PREFERRED PROJECT REPORT

**12-38 AND 40 BONAR STREET AND
5 LOFTUS STREET, ARNCLIFFE**

DECEMBER 2009

Figure 1: Location of additional height on Buildings A and D (shaded) and distance from Knoll Avenue properties

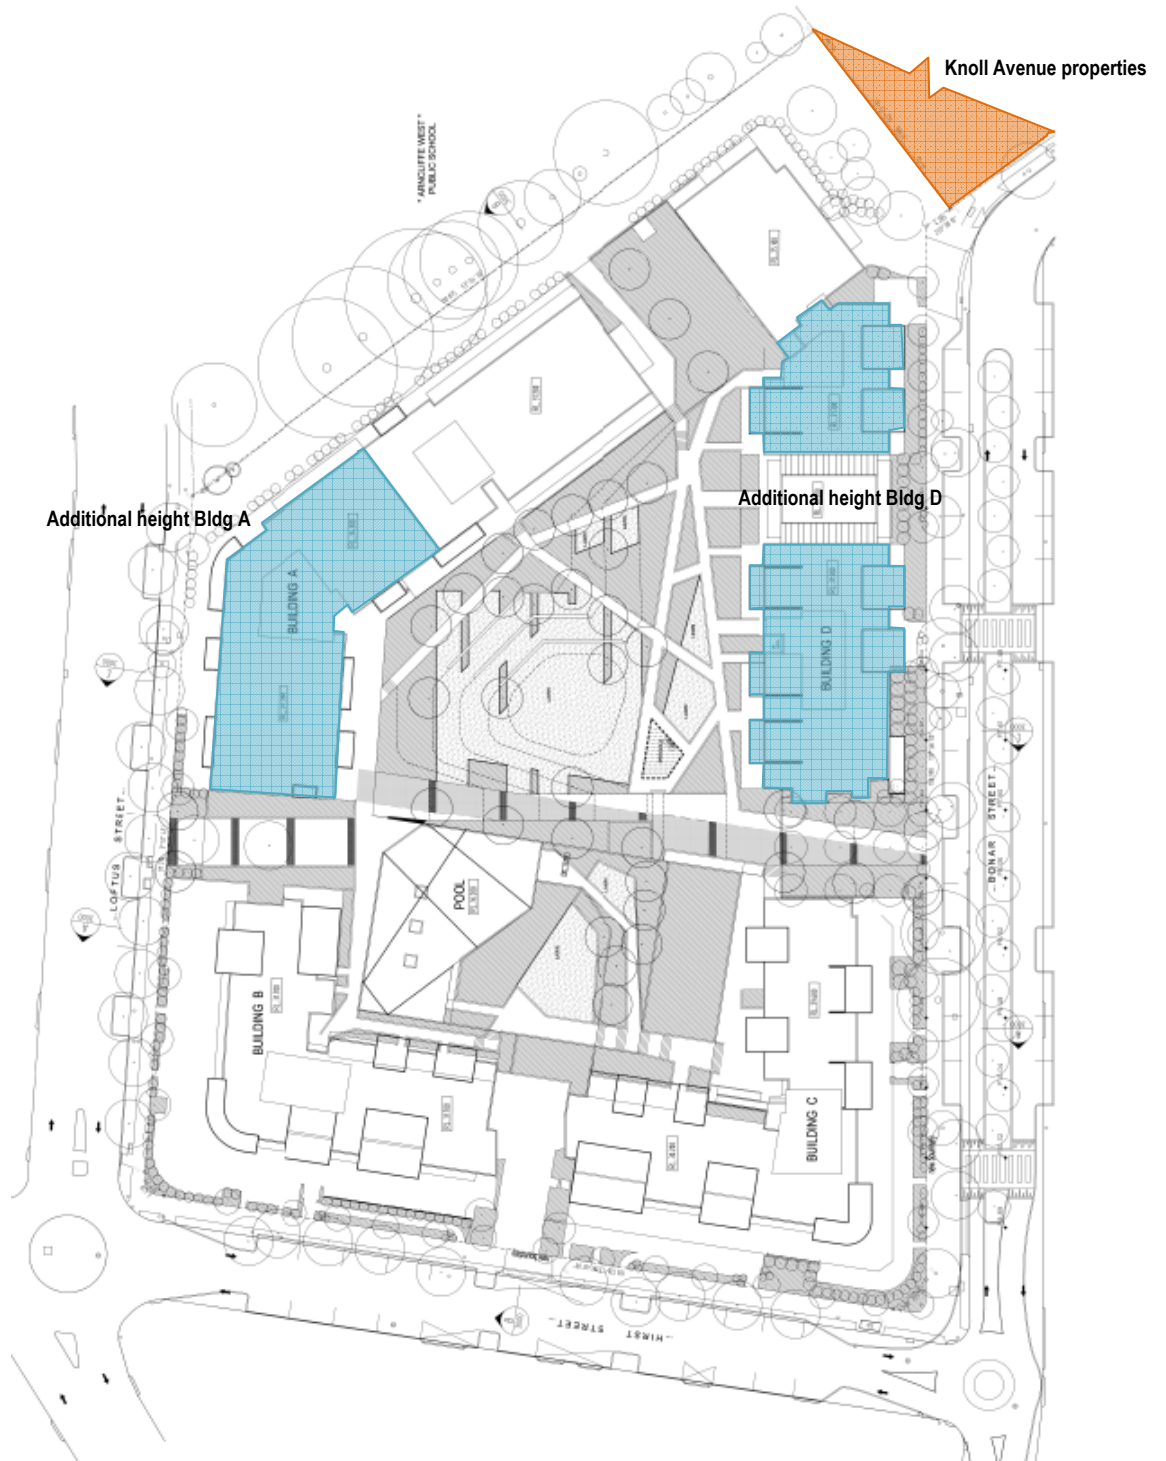
The residents raise issues with regard to noise, vibration and dust from excavation and future construction; the height of the proposed development; the 'blocking' of southerly breezes; and traffic and parking problems during and after construction.

With regard to building height, the proposal complies with the Council's LEP and DCP in the vicinity of the boundary shared with 2-6 Knoll Avenue. **Figure 1** shows that the location of the proposed additional height is not located near the existing Knoll Avenue or Hirst Street residents.

The building height adjacent to the boundary shared with 2-6 Knoll Avenue is proposed at 13 metres, which complies with the 15-metre height maximum on the LEP. **Figure 1** shows that the location of the proposed additional height is not located near the Knoll Avenue residents.
